INITIATION OF SCIENTIFIC PEER REVIEW ON TECHNICAL ISSUES CONTAINED THE DRAFT REGULATIONS FOR ONSITE WASTEWATER TREATMENT SYSTEMS

ENCLOSURE 1: SUMMARY OF THE PROPOSAL

ENCLOSURE 2: DESCRIPTION OF THE SCIENTIFIC PORTION OF THE PROPOSED REGULATIONS TO BE ADDRESSED BY PEER REVIEWERS

Figure 1: Design Infiltrative Surface Application Rates

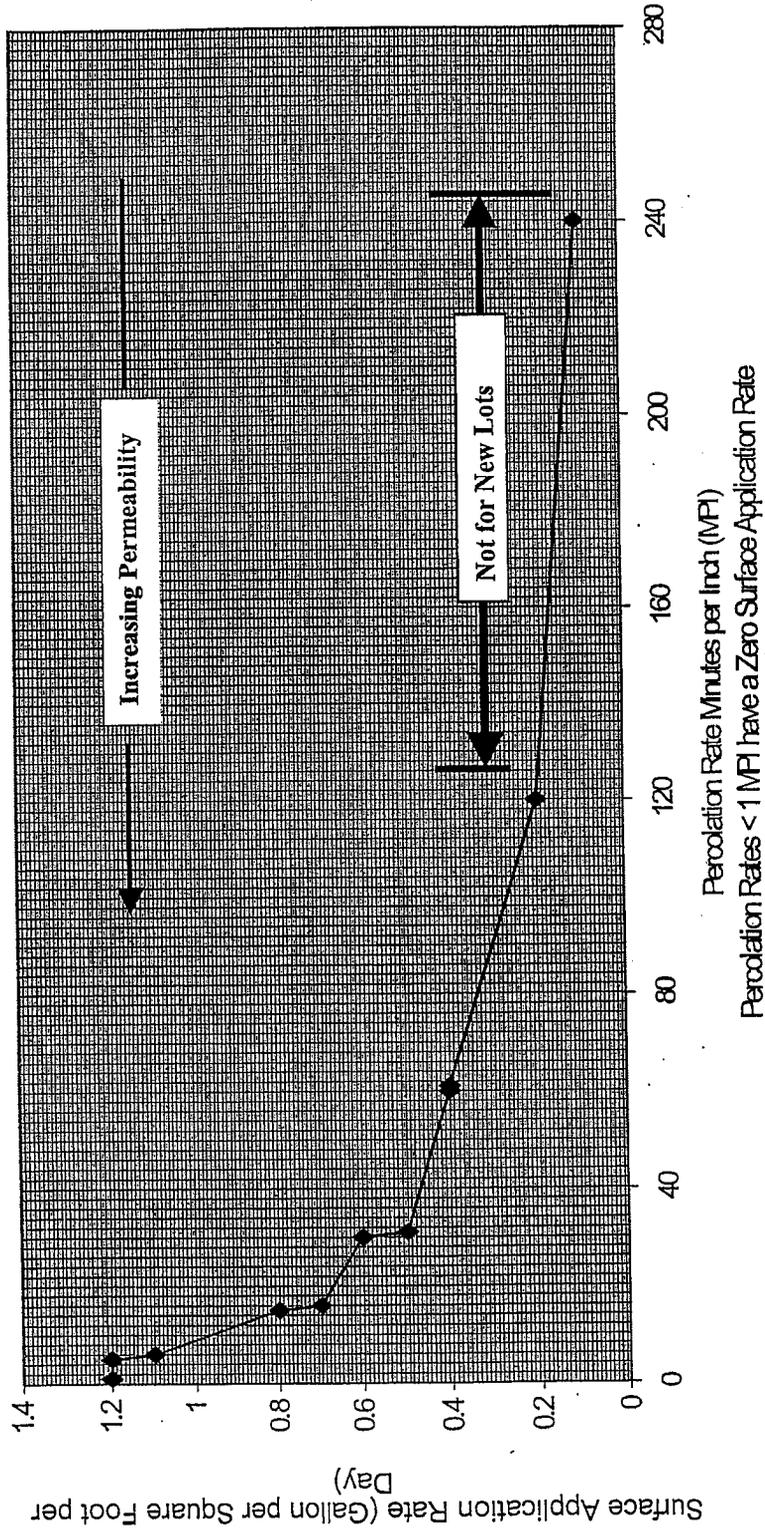
12. The proposed regulations specify maximum design application rates for sizing the dispersal systems in Figure 1 and Table 2.

Issue 12: Appears to be standard design criteria; no comment.

Figure 2: Minimum Depth of Earthen Material

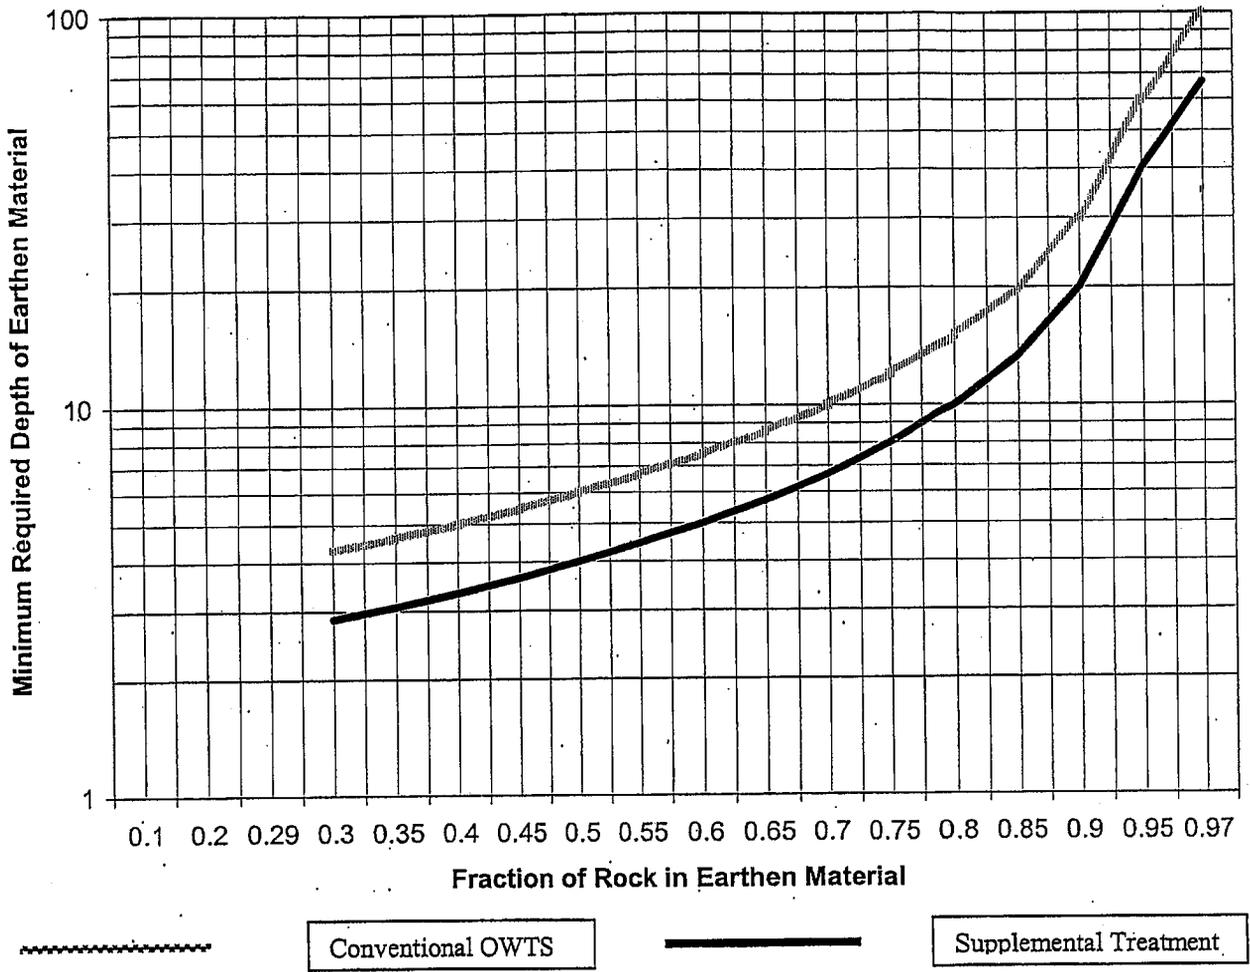
13. The proposed regulations (Figure 2, §24914(c) and 24914(d)) would require additional unsaturated soil depth where excessive rock fragments exist in the dispersal system.

The 'Y-axis' in Figure 2 does not have units.
